RICHMOND COMMUNITY SCHOOL
Richmond High School: Mechanical Modernization Project
LWC Commission No. 20104.02

ADDENDUM #03
October 3, 2021

Comm. No.	Date
20104.02	06.18.2021
Drawn	Drawing No.
TOD	A105
Checked	KRM

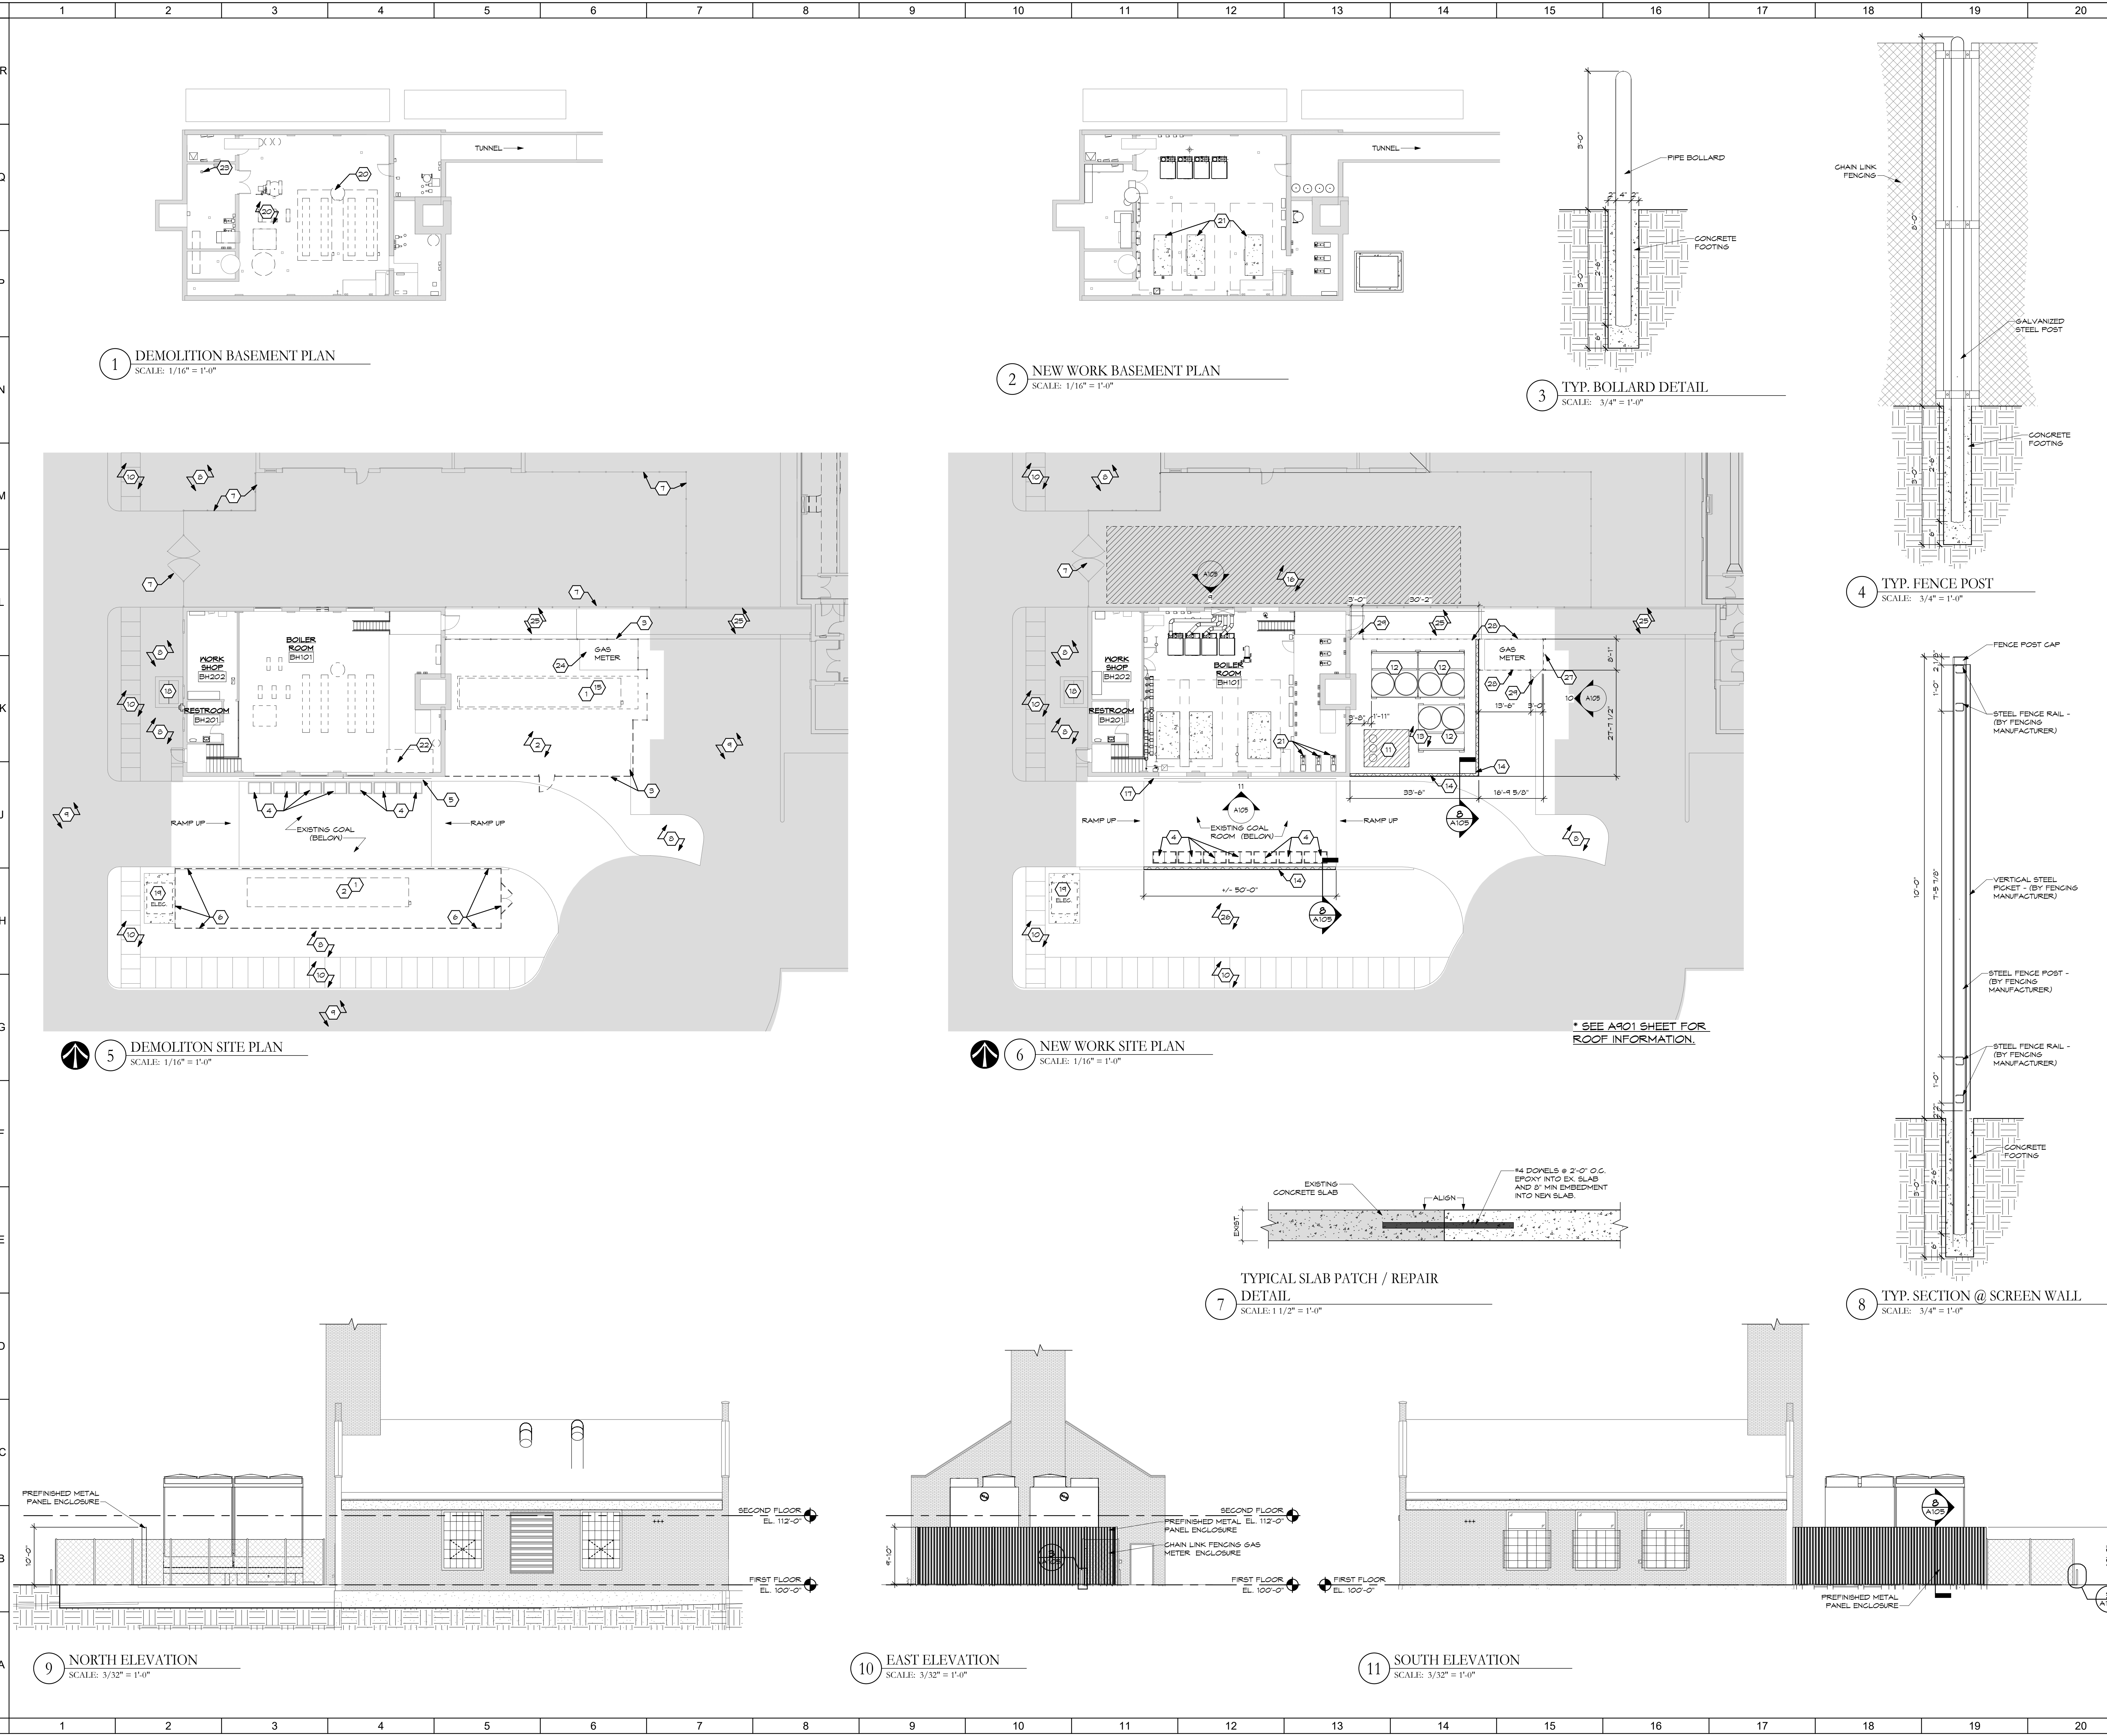
ITEM NO.1 Drawing A105

- A. Revised Sheet Note #27.

Comm. No.	Date
	20104.02	8.27.2021
	Drawn	Drawing No.
JDW	P101	
Checked	BSB

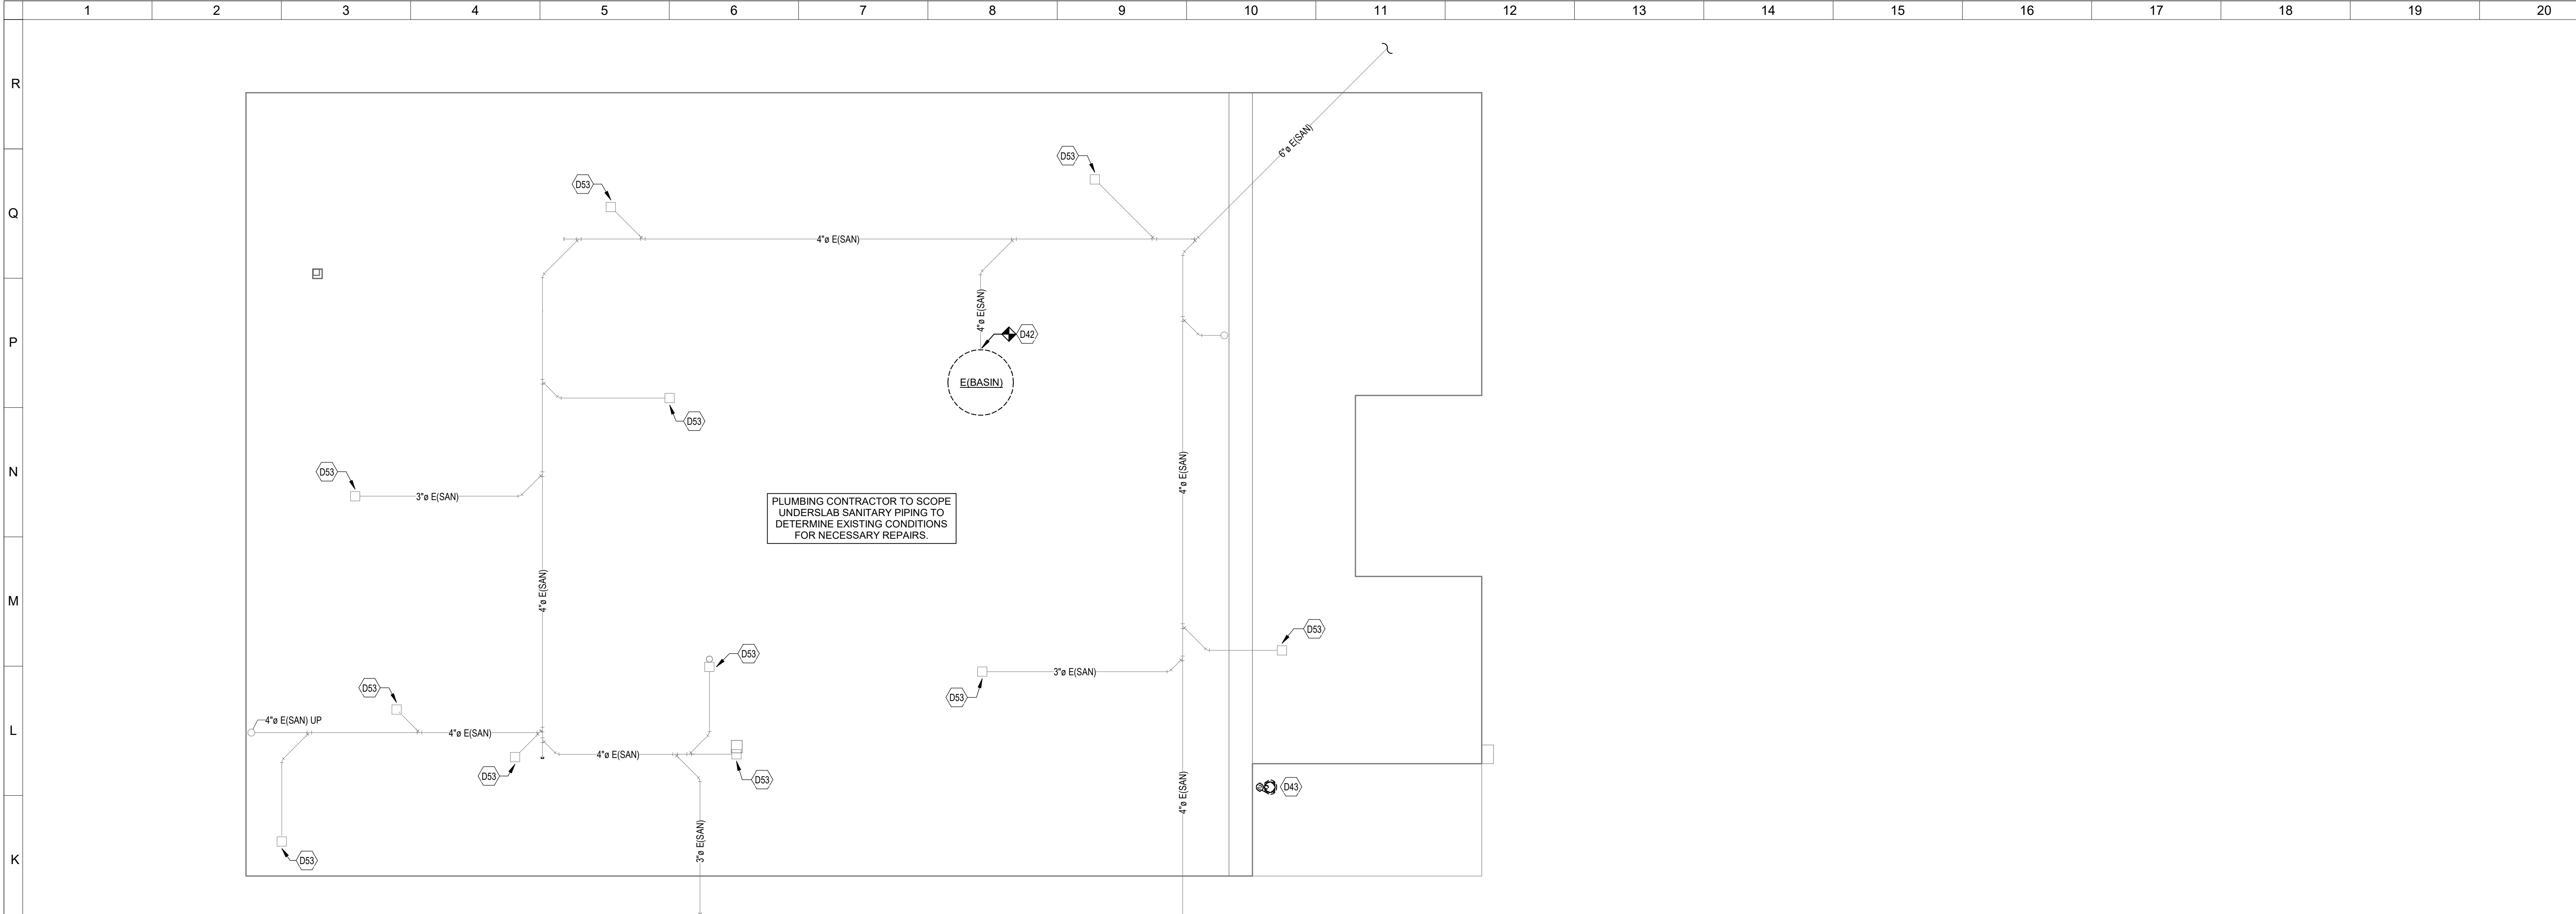
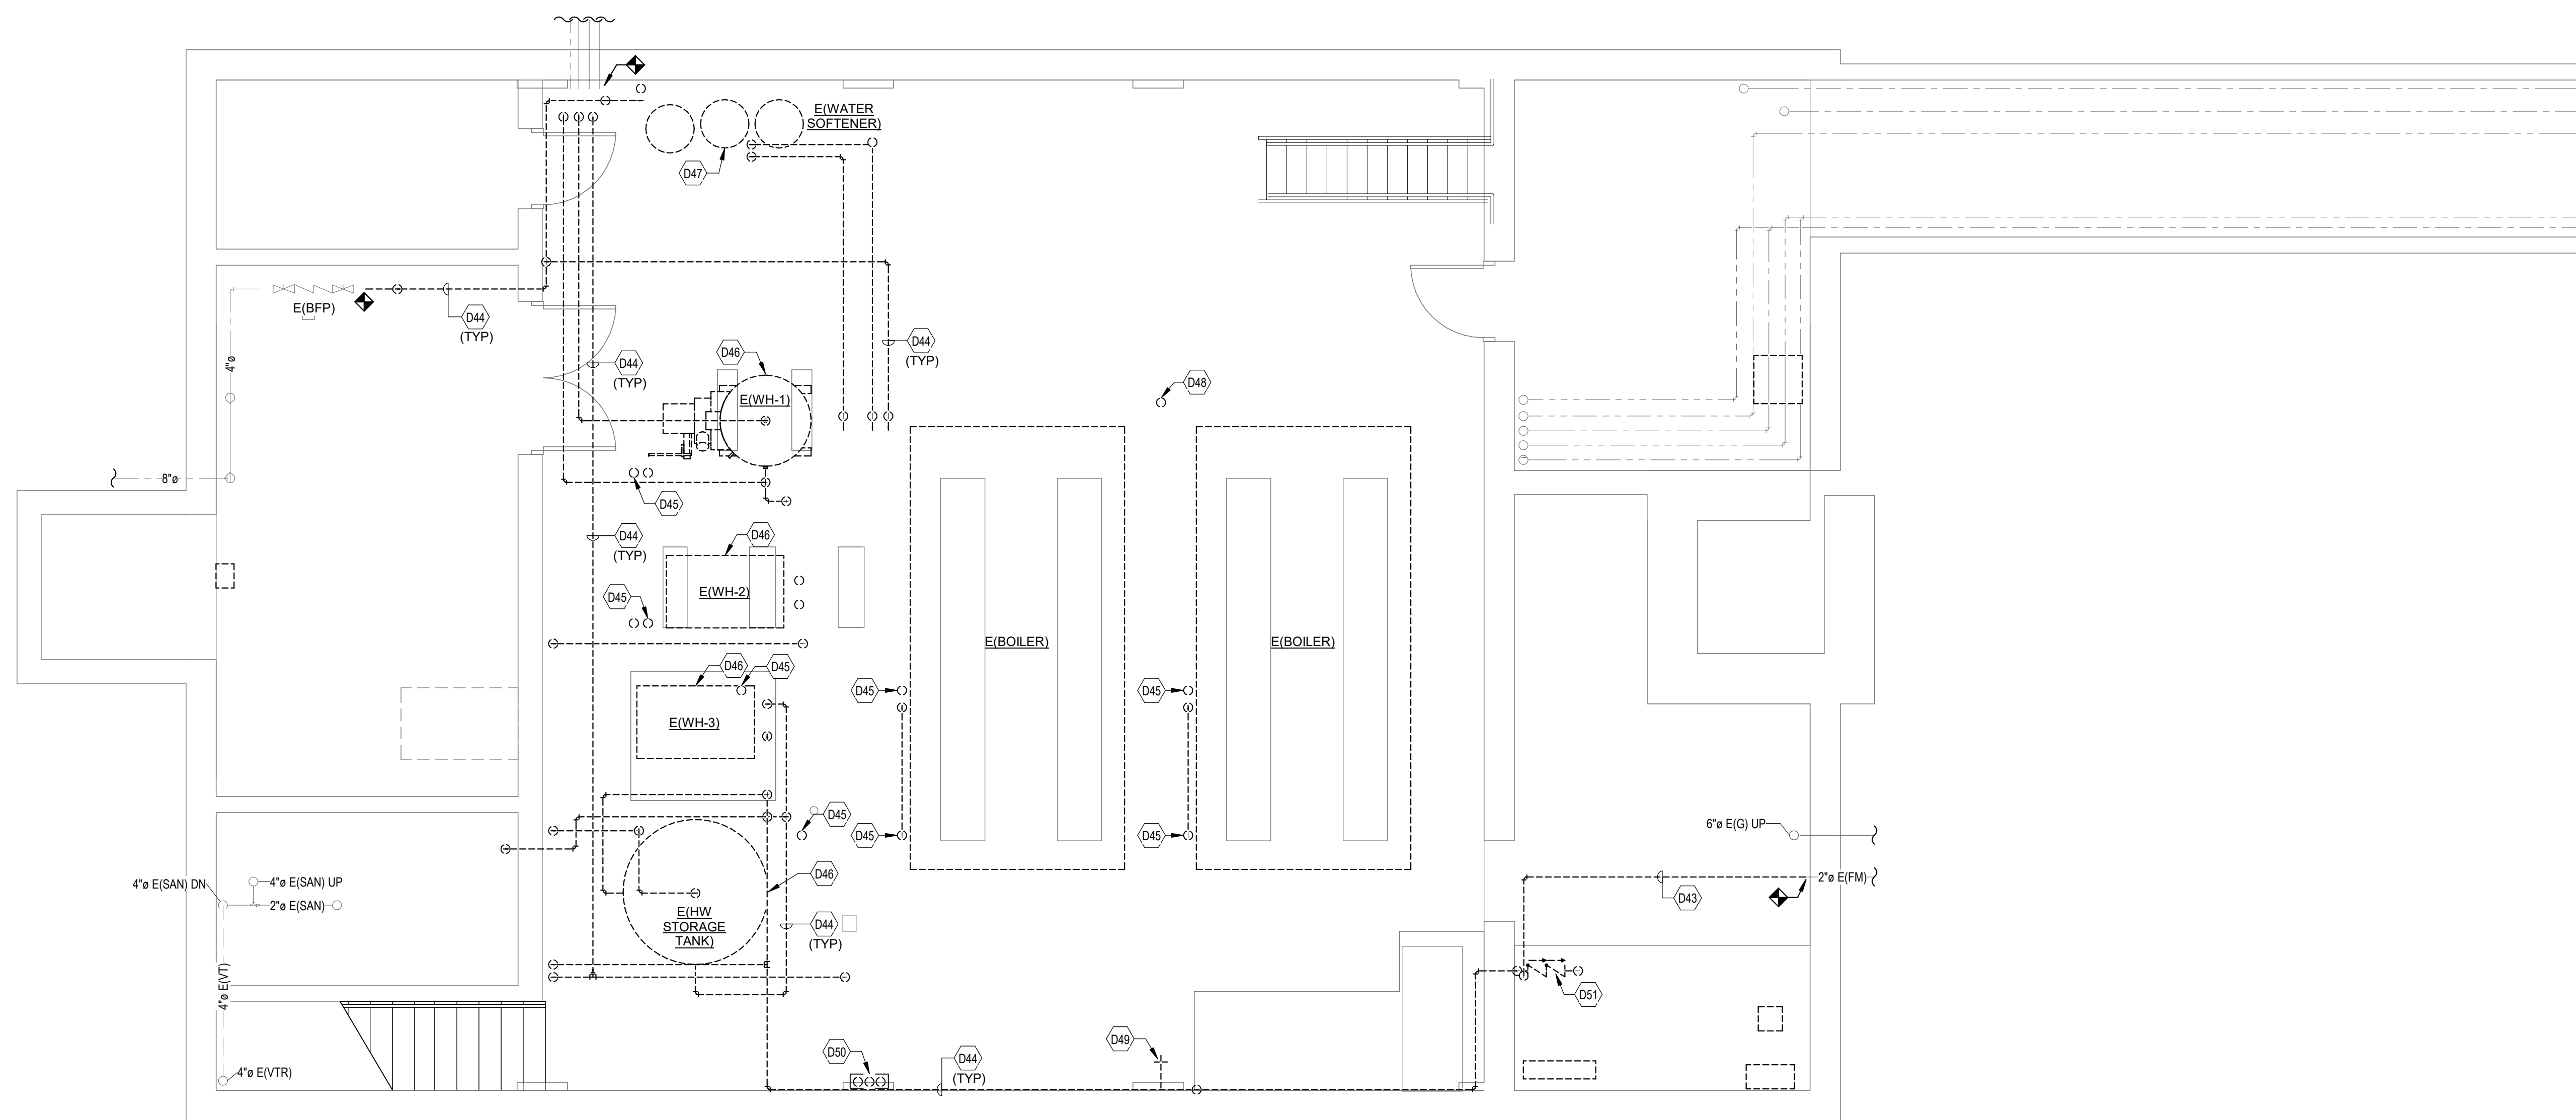
ITEM NO.2 Drawing P101

- A. Added more information to tagged note D46.
